GPU Nuclear, Inc.
Route 441 South
Post Office Box 480
Middletown, PA 17057-0480
Tel 717-944-7621
717-948-8720

February 4, 2002
E910-02-005

Subject: Saxton Nuclear Experimental Corporation (SNEC)
Operating License No., DPR-4
Docket No. 50-146
Supplemental Response to RAI #2 Questions

Response to SNEC RAI2 (Questions 4-9)

FIGURE 1
REVISION 1

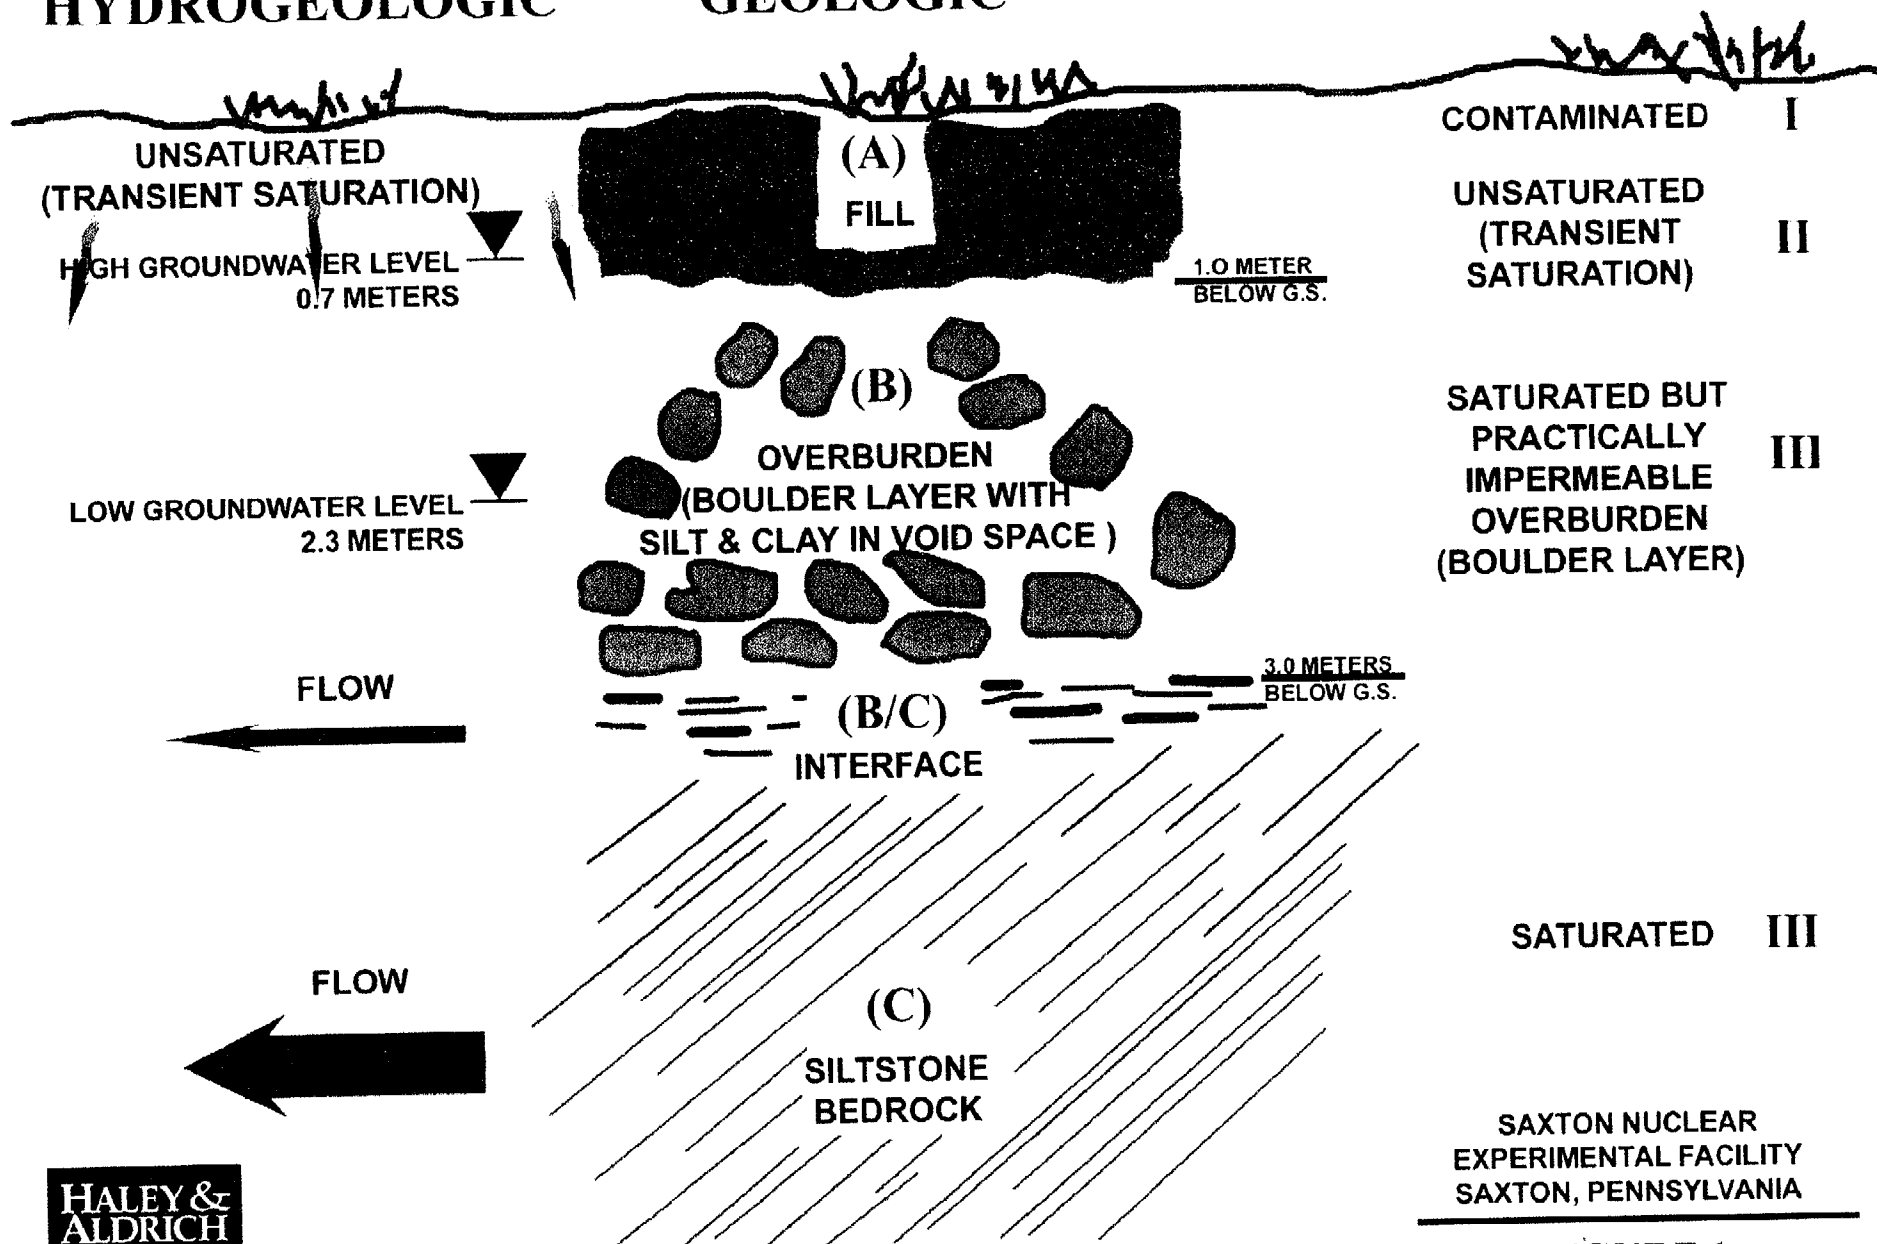
Resident Farmer Assumptions and Justifications used to Demonstrate Compliance-
Please describe the assumptions and provide justifications for the parameters used in the RESRAD calculation of the site-specific DCGLs for contaminated soil. Specifically, provide justification for the parameters listed in the attached Table 1. Guidance on sources of information for providing acceptable justification for parameters used in dose assessments can be found in the "Draft Technical Basis Document to the Standard Review Plan for Decommissioning," which is located at <http://www.nrc.gov/NMSS/DWM/DECOM/dosemodel.htm>.

There is approximately 7 to 18 feet of overburden material overlying bedrock (a fractured siltstone). The overburden materials generally consist of fill overlying a natural boulder layer with silt and clay filling the interstitial spaces. Groundwater occurs in both the overburden/bedrock interface and the fractured bedrock. A detail description of each unit follows and Figure 1 shows a generalized cross section of these materials.

For the surface model, a contaminated zone is located between approximately 0 and 1.0 meter, as shown on Figure 1. Based on subsurface investigations as described in Section I, the geologic stratigraphy at this depth is described as mixed soils, sandy or silty clay to well graded sand and gravel with rock fragments. Based on the May 1982 Department of Navy Naval Facilities Engineering Command (NAVFAC) DM-7.1 Manual, dry weight density for this type of material is in the range of 80 to 120 lb./ft³ (or 1.28 to 1.92 g/cm³). The range for dry weight as opposed to wet, or submerged weight was used, as the depth of soil contamination is unsaturated. The value input into the RESRAD model was 1.60 g/cm³, the average of the above-stated range.

Based on subsurface investigations as described in Section I, the geologic stratigraphy of the saturated zone is described as mixed soils and bedrock. As denoted in Figure 1, units B, B/C and C are considered saturated and only units B/C and C subject to any appreciable flow of groundwater. Further, based on the thicker saturated thickness of unit C in relationship to unit B/C and other pertinent information we recommended combining the interface and bedrock units (B/C and C) and using values for the siltstone bedrock for the RESRAD inputs.

As noted earlier, the contaminated zone is present to 1.0 m below ground surface for the modeled area (Figure 1). The saturated zone begins at approximately 1.5 m below ground surface, and given the seasonal variation of the water table, the unsaturated zone exists (and varies) from 1 to 1.5 m below ground surface. During a period of one to two months in the spring water levels may be higher than throughout most of the hydrologic year resulting in a period of transient saturation. Therefore, 1 was input for the number of unsaturated zone strata.

As noted above, the unsaturated zone exists (and varies) from 1 to 1.5 m below ground surface. Therefore, the unsaturated zone thickness ranges from 0 to 0.5 m (see Figure 1). The value input into the RESRAD model was 0.25 m, the average of the above-stated range.
